SHERMAN, ILLINOIS
TR 33 (WOLF CREEK RD)
M.P. 176.60
SPRINGFIELD SUBDIVISION
D.O.T.#294 280R

UNION PACIFIC RAILROAD
BLOOMINGTON, ILLINOIS TO VALLEY JCT., ILLINOIS
C.T.C. CIRCUITS
Office of AVP Engineering-Signal OMAHA NEBR.

Designed: 08/21/12
TIER 3 PHASE 3
M.P.177.00 TO
M.P.160.00
UPGRADE XINGS AND
CP'S FOR HIGH
SPEED RAIL
Rec*: WO*: 22820
IS: /MWK
/ /NST,MJF

DATE 6-20-08
SHEET 9
DWG 136.35
RTE-CSL

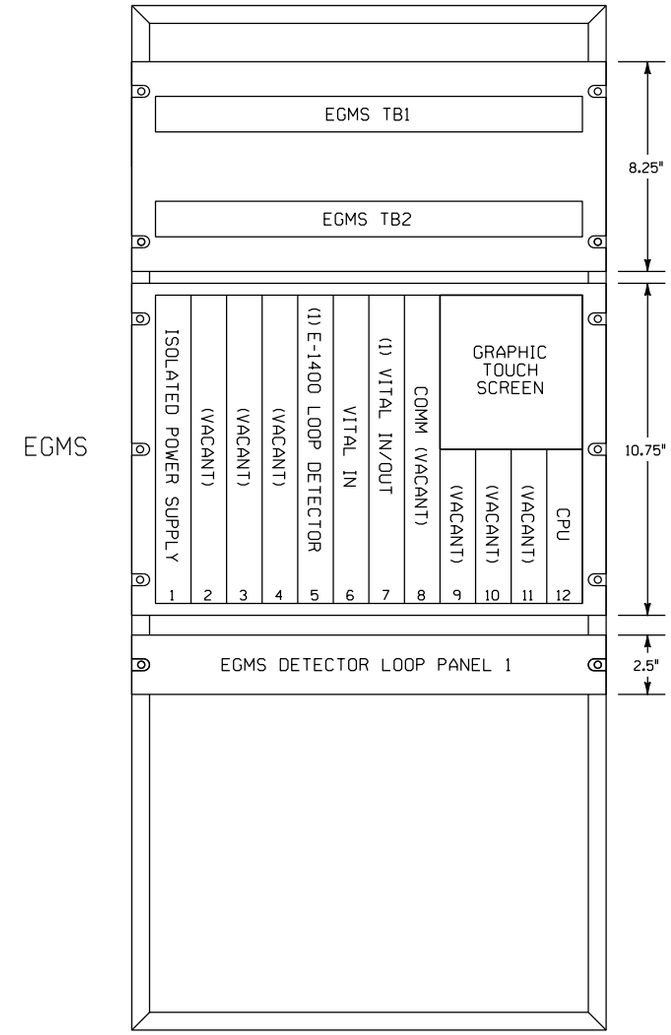
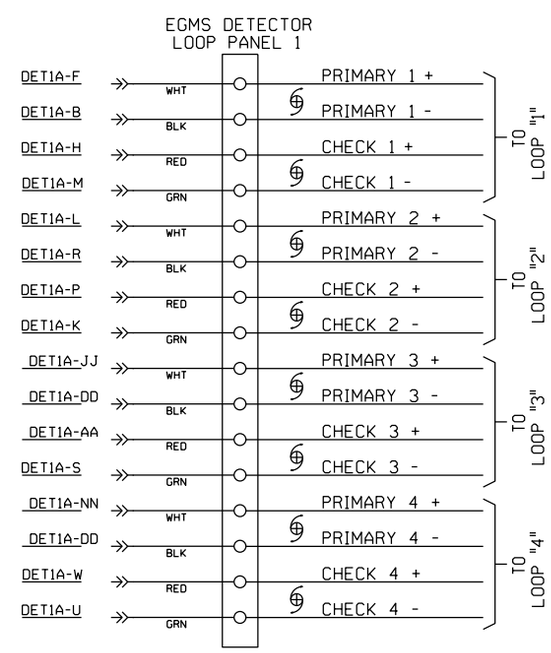
TO BE VOIDED
08/21/12
W.O. 22820 NST/MJF

DATE 4-1-02
SHEET 11 12
DWG 176.60
RTE-CSL

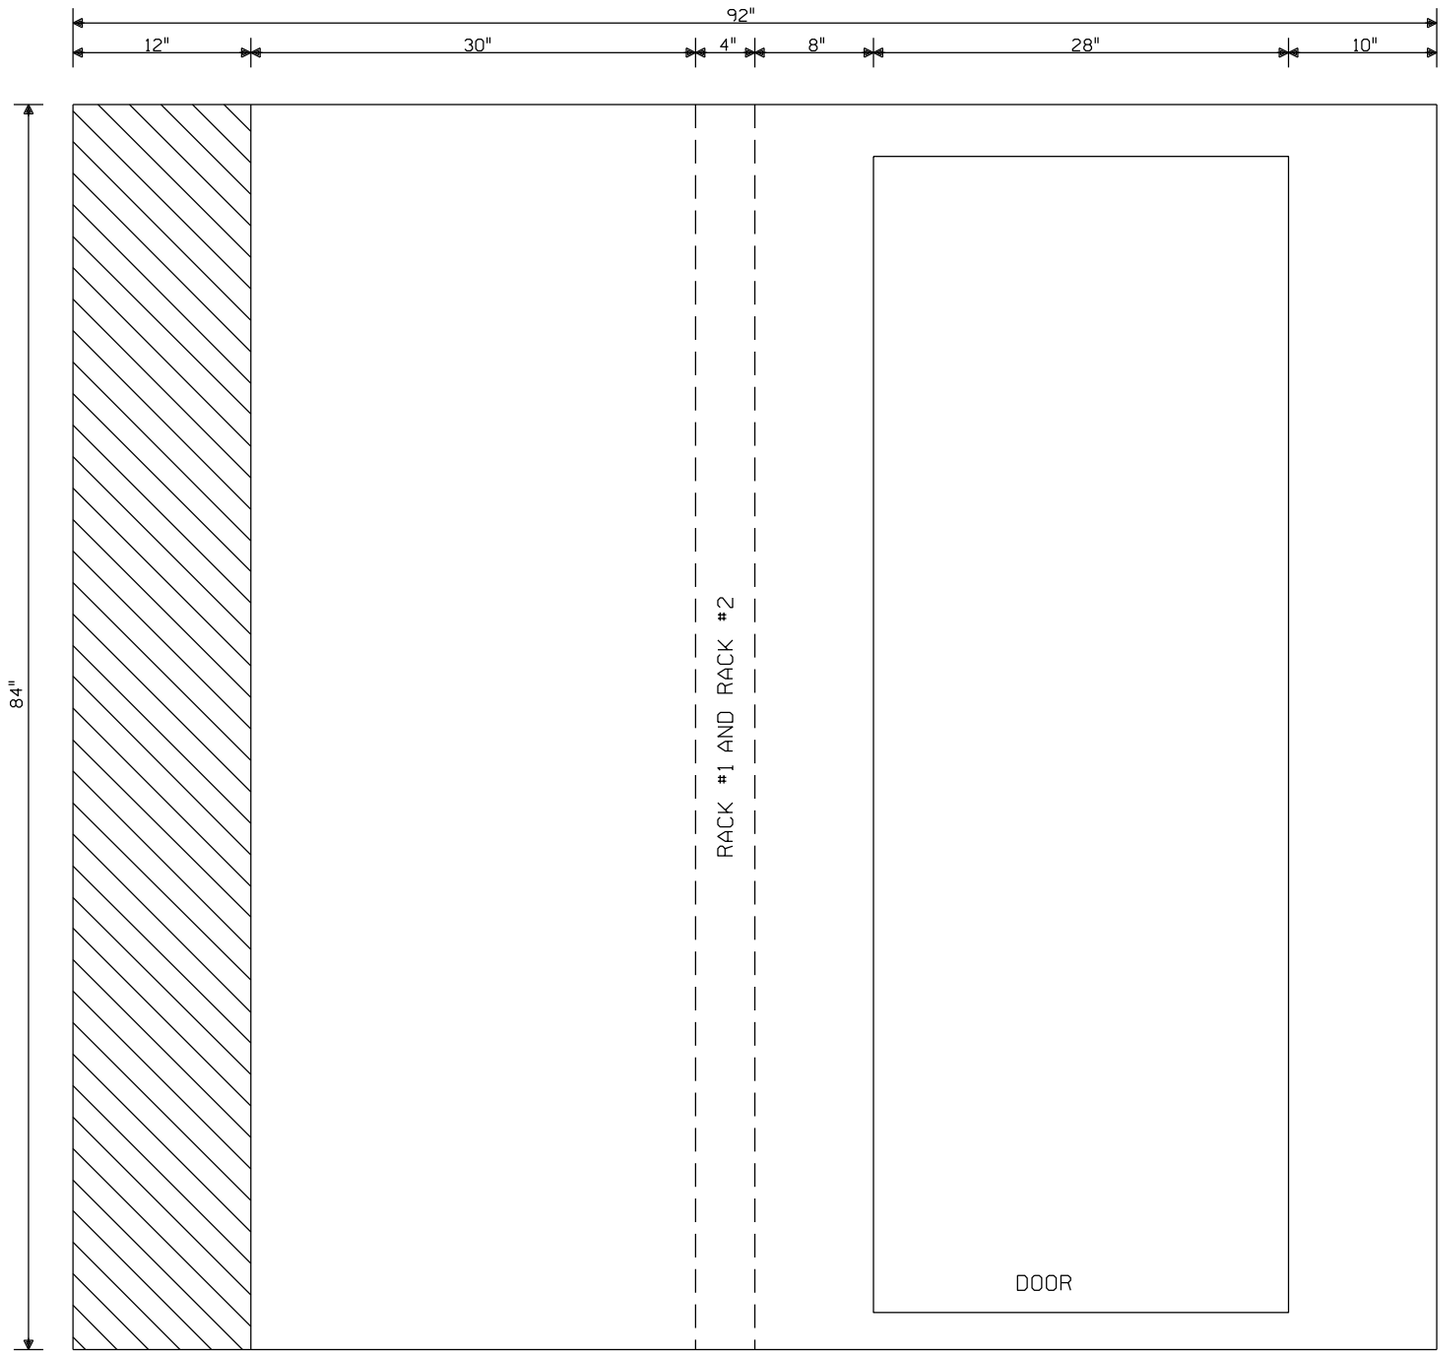
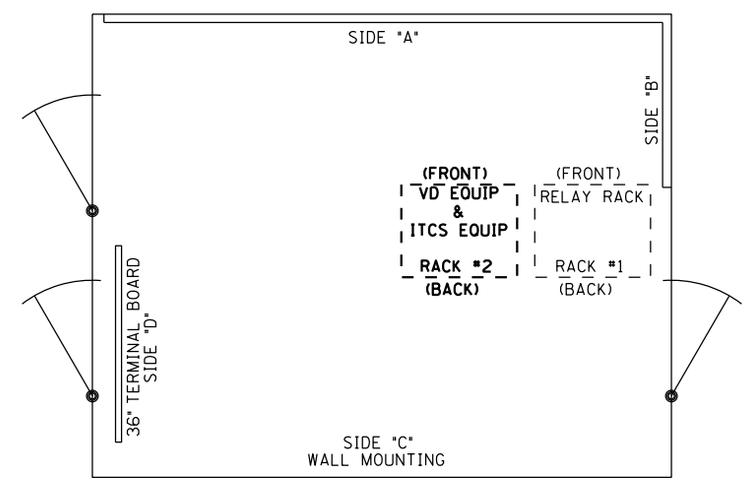
FIELD TO VERIFY LOCATION OF ANTENNAS, AND SURGE SUPPRESSORS FOR ATENNAS.
